- 4 17/1461/REM: Cycleway/footway - Land Adjacent to Cambridge Guided Busway and Adjacent to existing plantation within abode 1 (Parcels 10, 11 and 12), Clay Farm, Trumpington, Cambridge. (PAGES 7 - 20)

JOINT DEVELOPMENT CONTROL COMMITTEE (CAMBRIDGE FRINGE SITES)

Application Number	17/1461/REM	Agenda Item	
Date Received	25 September 2017	Officer	Aaron Coe
Target Date	24 January 2018		
Parishes/Wards Site	Trumpington Land Adjacent to Cambridge Guided Busway And Adjacent to Existing Plantation Within Abode 1 (Parcels 10, 11 and 12), Clay Farm, Trumpington, Cambridge.		
Proposal	Reserved matters application pursuant to outline approval 07/0620/OUT for the construction of a new cycleway and footway on land adjacent to the Cambridge Guided Busway (CGB) route and Abode 1 residential development.		
Applicant	Countryside Properties Ltd		
Recommendation	Approve Subject to Conditions		
Application Type	Reserved Matters	Departure: No

CF-03: PERMEABLE CUT THROUGH CONSTRUCTION DETAIL
Scale 1:5

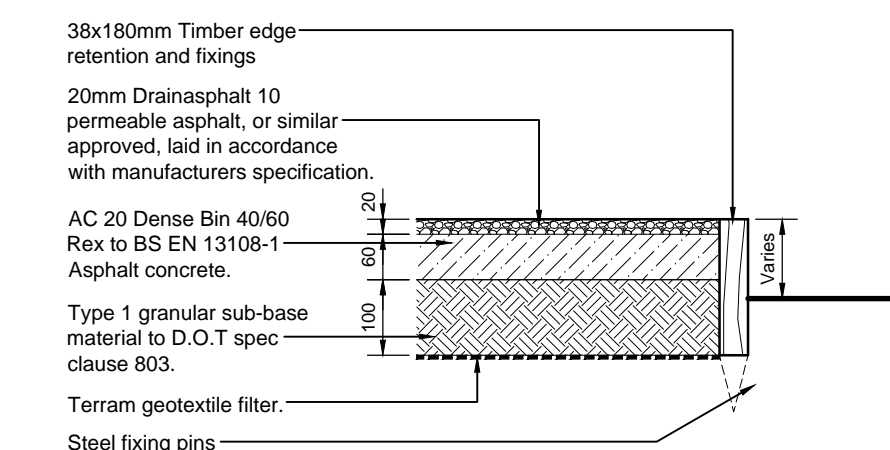
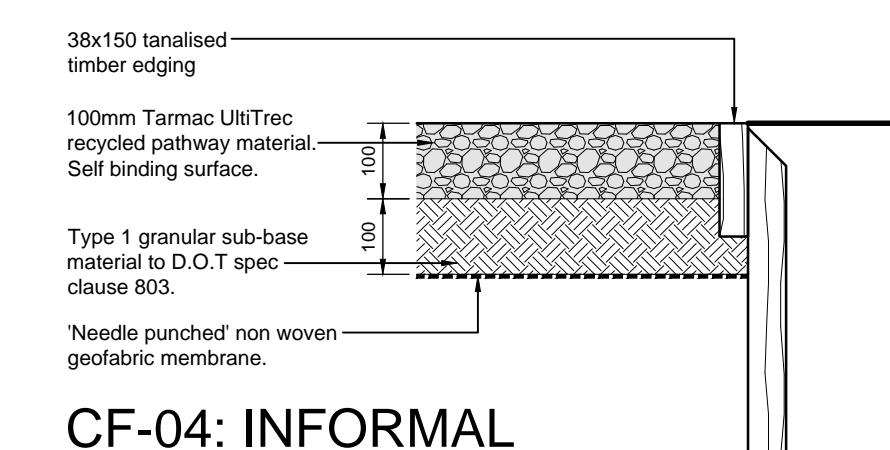
- 6.5 There should not be a 10mm upstand to the pin kerb detail along the edge of the path as this will trap water runoff as well as cause a cycle wheel hazard. It must be flush.

The specification for the lights quoted on the drawings should include particular reference to adequate drainage around the lights in line with the manufacturer's recommendations.

The development proposed is acceptable.

PLAN C
Scale 1:200

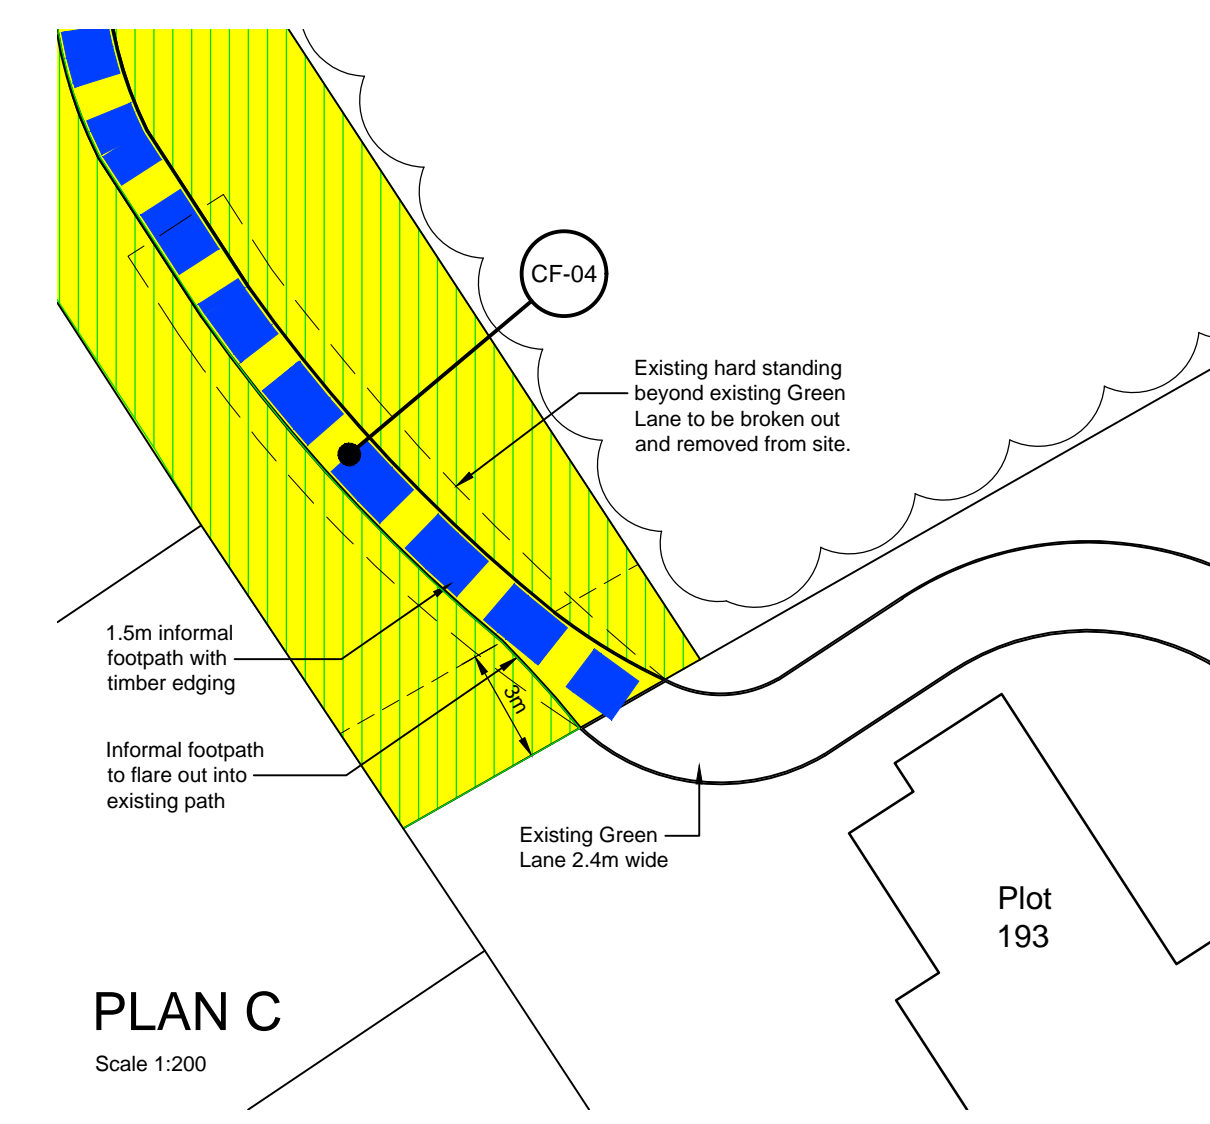
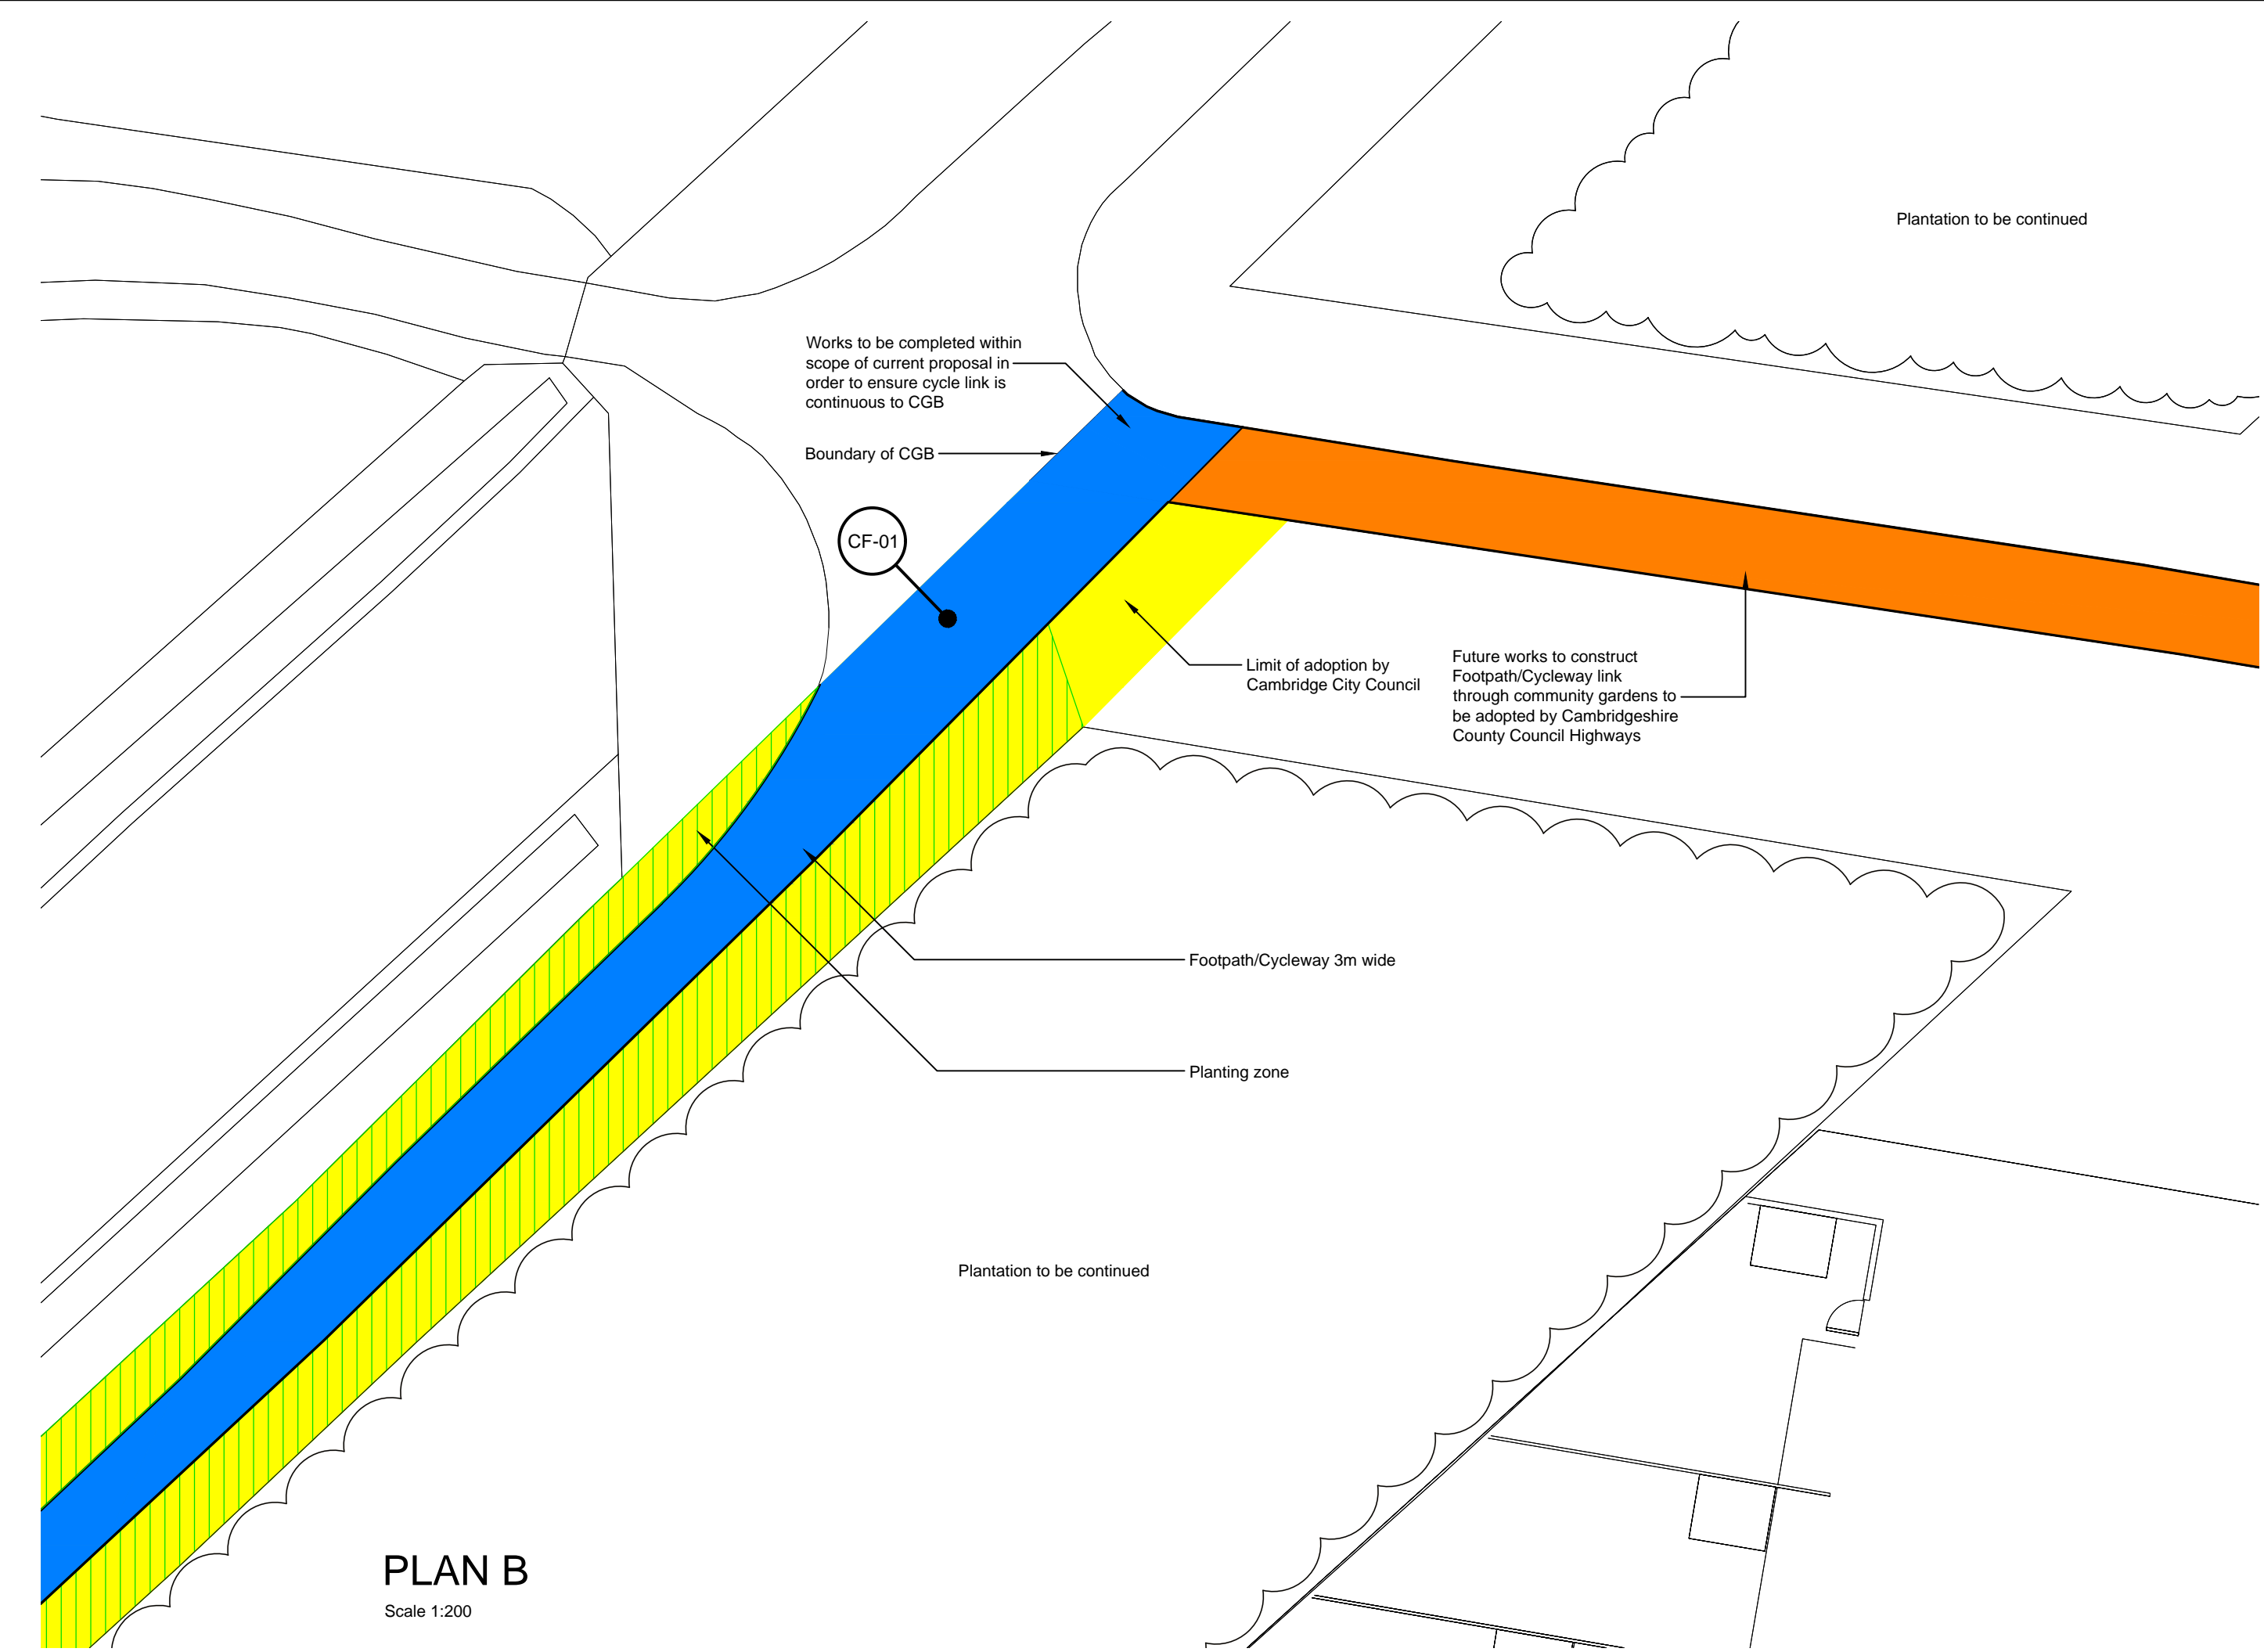
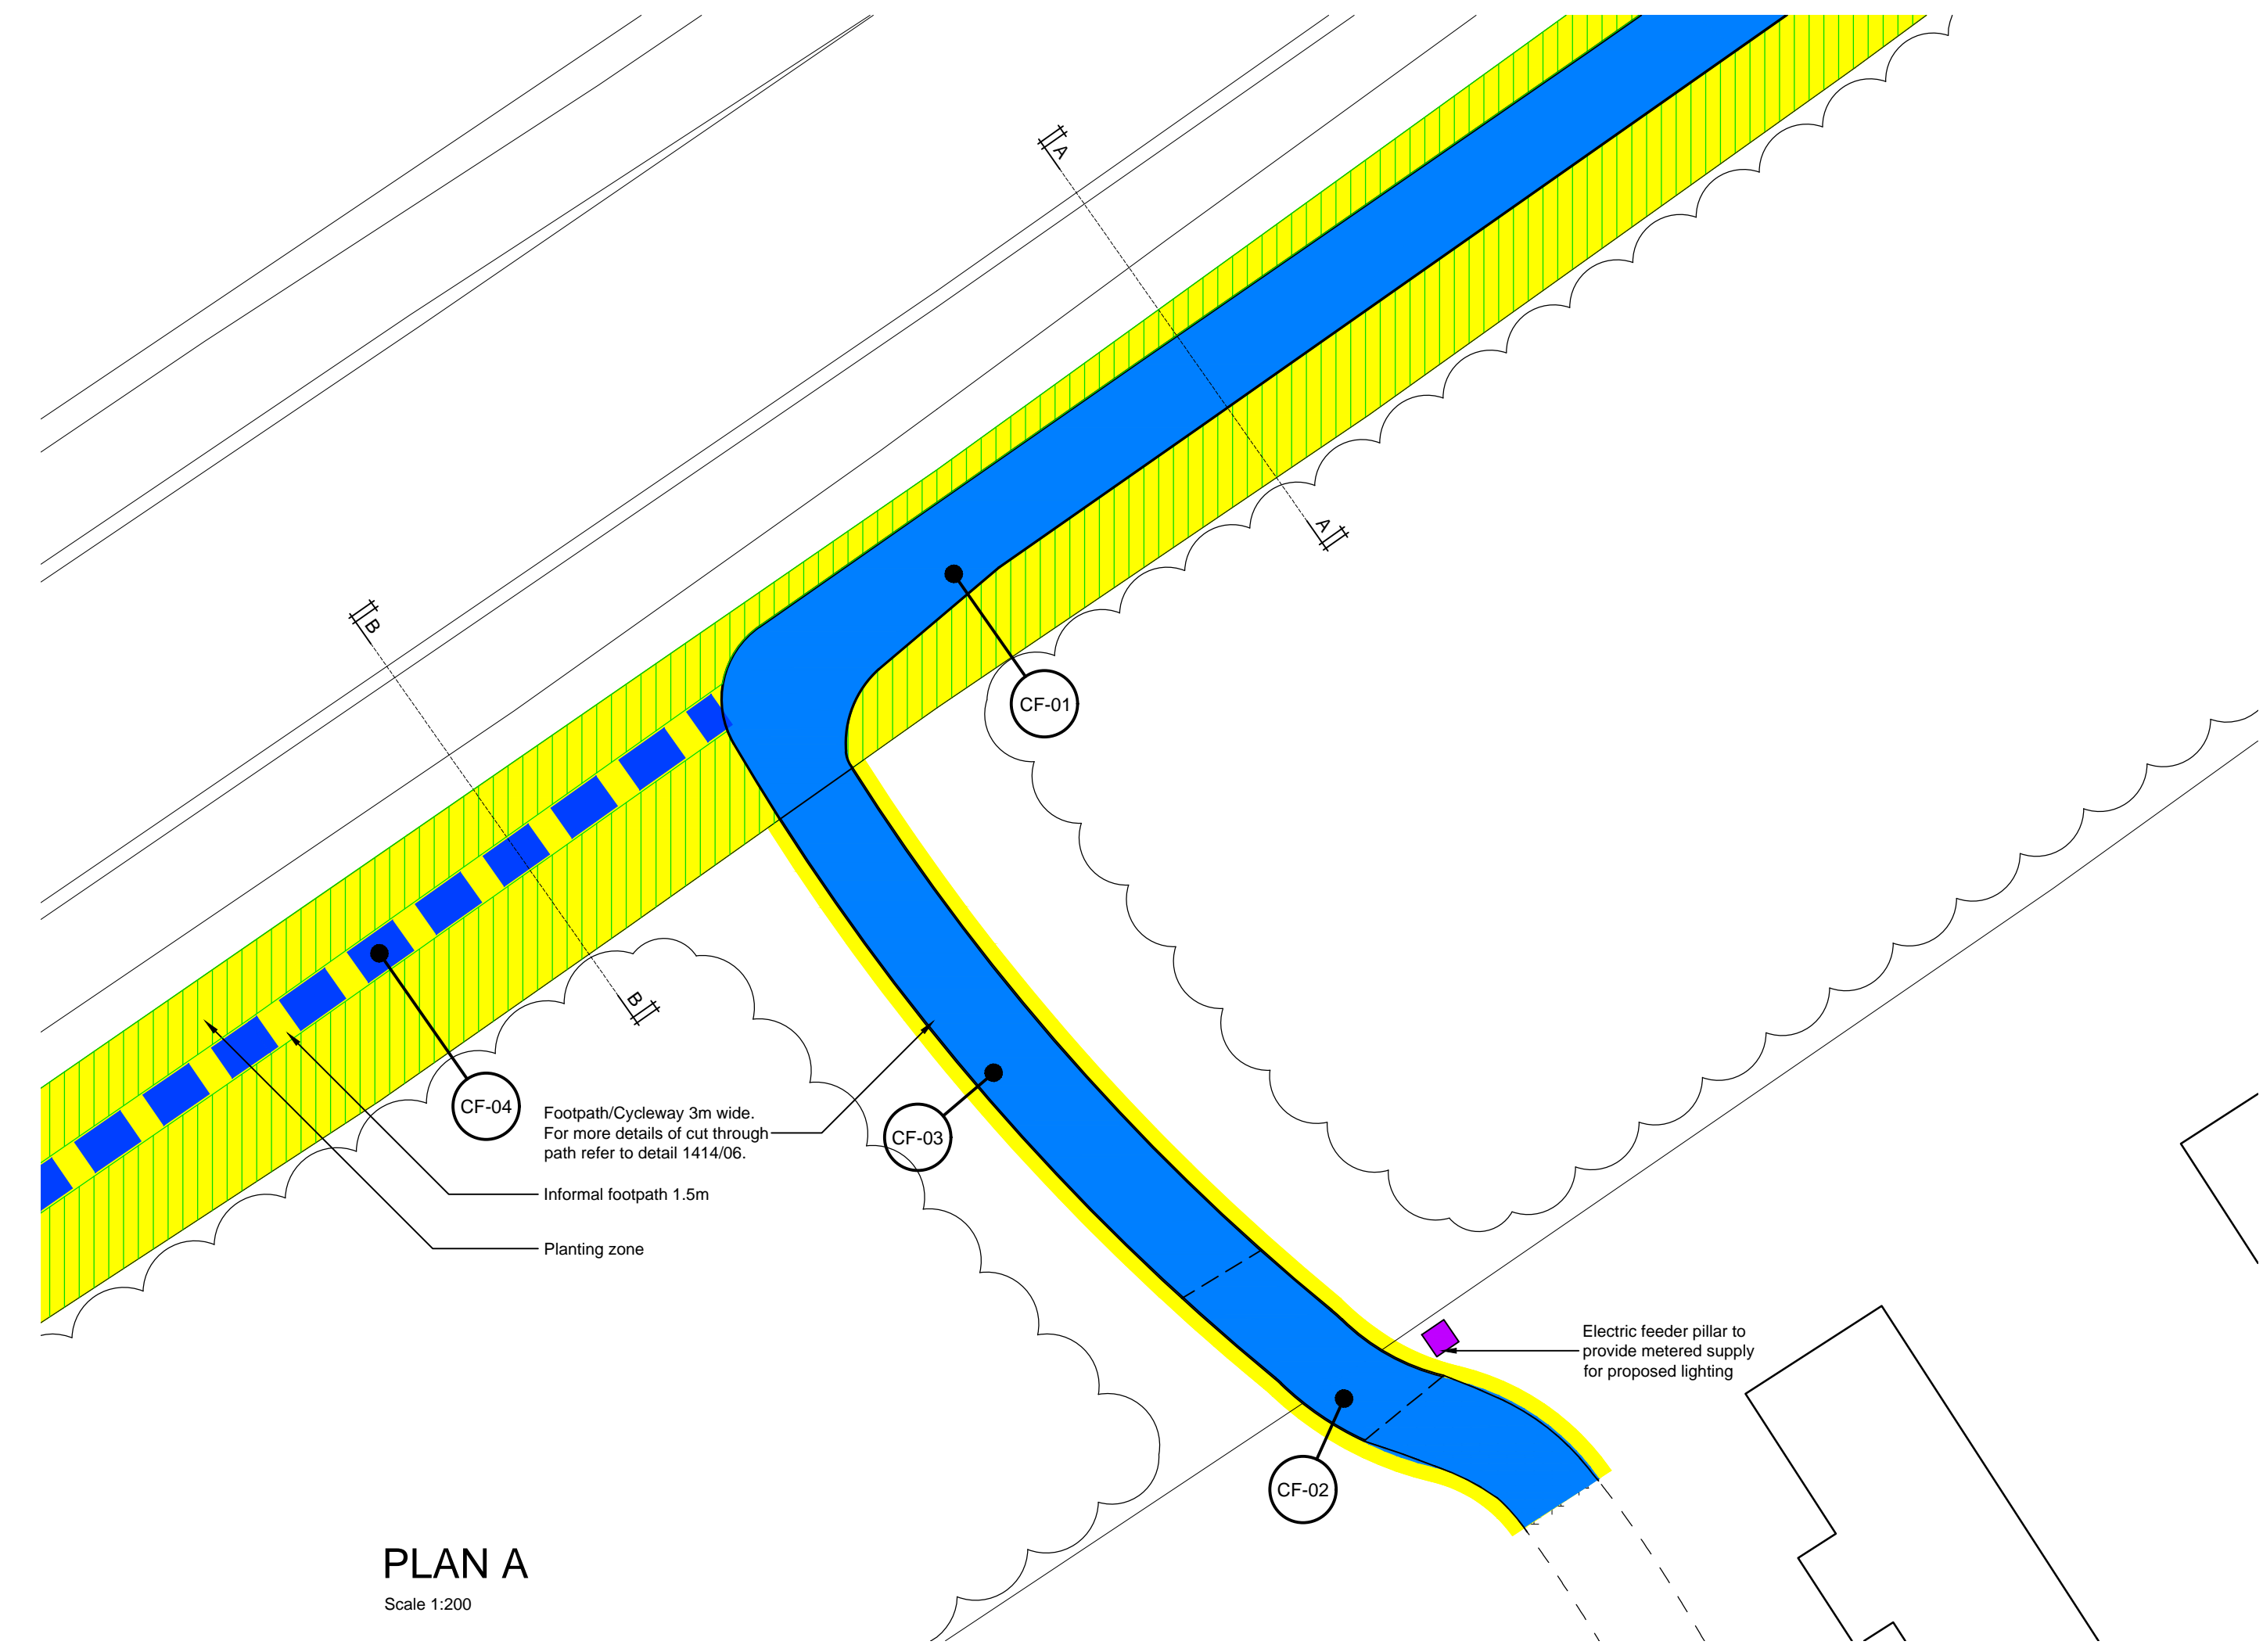
6.1 The cycleway route includes a sharp 90° bend.

Whilst it is desirable, for the safety of pedestrians, to encourage cyclists to slow down at this point, a tight radius should be provided to facilitate the turn by larger pedal vehicles and the cycleway widened slightly to reduce cycle/cycle conflict.

- The existing route alongside and cutting into the development near 'plot 193' should be made up as a footpath/cycleway rather than an 'informal footpath' as this is a natural route for residents to follow.
- Concerns regarding the protection of the existing tree belt
- Concerns about the 90 degree bend (visibility) and positioning of any vertical obstructions (e.g. lighting posts).
- Concerns regarding drainage

- 6.2 The amended proposals are considered acceptable.

15.1 Visibility issues were raised by a resident and by Highways regarding the 90 degree bend from the cut through onto the proposed cycleway. Subsequently the applicant has amended the proposals by widening this part of the footpath and making the bend less sharp, these alterations have been considered acceptable.

rev	date	by	description
PL3	14/12/17	ASD	Footpath/Cycleway corner widened to avoid conflict and details amended.
PL2	07/12/17	ASD	Plan C added, Details CF-01 - 04 and references added.
PL1	07/11/17	ASD	Plan A path route amended and Tree indicated in accordance with Arboricultural Report.
